WBN-TS-05-07

WATTS BAR NUCLEAR PLANT (WBN) UNIT 1 TECHNICAL SPECIFICATION REQUEST WBN-TS-05-07 ONE-TIME FREQUENCY EXTENSION FOR TYPE A TEST REQUEST FOR ADDITIONAL INFORMATION

CALCULATION CN-NUC-WBN-MEB-MDN00199920050099

REV 0 EDMS/RIMS NO. T71051101801				EDMS TYPE: calculations(nuclear)		EDMS ACCESSION NO (N/A for REV. 0) T71 060323 817			
Calc Title: EVALUATION OF THE RISK SIGNIFICANCE OF DECREASED CONTAINMENT INTEGRATED LEAK RATE TEST FREQUENCY									
CALC ID	TYPE	ORG	PLANT	BRANCH	NUMBER	CUR REV	NEW REV	REVISION APPLICABILITY	
CURRENT	CN	NUC	WBN	MEB	MDN00199920050099	1	2	Entire calc. <input checked="" type="checkbox"/> Selected pages <input type="checkbox"/>	
NEW									
ACTION	NEW REVISION <input checked="" type="checkbox"/>	DELETE RENAME <input type="checkbox"/>	SUPERSEDE DUPLICATE <input type="checkbox"/>	CCRIS UPDATE ONLY <input type="checkbox"/> (Verifier Approval Signatures Not Required)			No CCRIS Changes <input type="checkbox"/> (For calc revision, CCRIS been reviewed and no CCRIS changes required)		
UNITS	SYSTEMS				UNIDS				
1	999				N/A				
DCN.EDC.N/A N/A		APPLICABLE DESIGN DOCUMENT(S) N/A				CLASSIFICATION D

Figure 1
Probability of exceedance of 0.30g pga

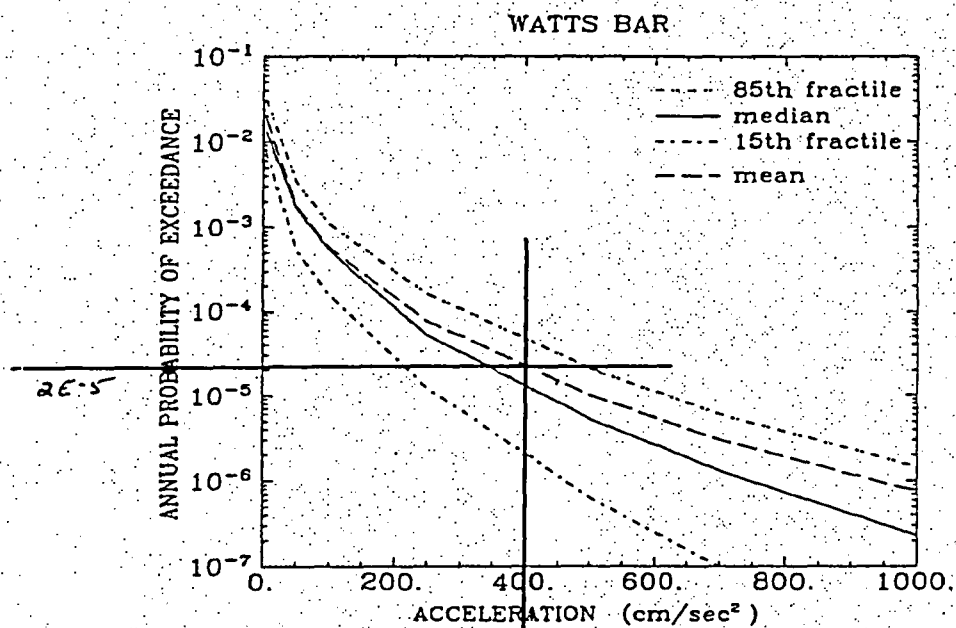
In Enclosure 4, it is assumed that the LERF associated with both internal and external events can be estimated by doubling the LERF associated with only internal events. This simplified approach has been accepted by the NRC if sufficient justification is provided that the core damage frequency (CDF) from external events, including seismic and fire events, is approximately equal to or less than that for internal events. Although fire risk is discussed briefly in Section 9.0, the contribution from seismic events was dismissed on the basis that the seismic margin assessment did not calculate seismic CDF or LERF. Provide additional justification that the contribution from seismic events is small. This could be based on simplified methods such as those utilized in the Browns Ferry ILRT extension request.

TVA's attached calculation was revised to include a quantitative assessment of the impact of seismic events based upon a simplified method used in the BFN ILRT extension request.

From Figure 1, the annual probability of exceedance for C_{10%} is approximately 2E-5.
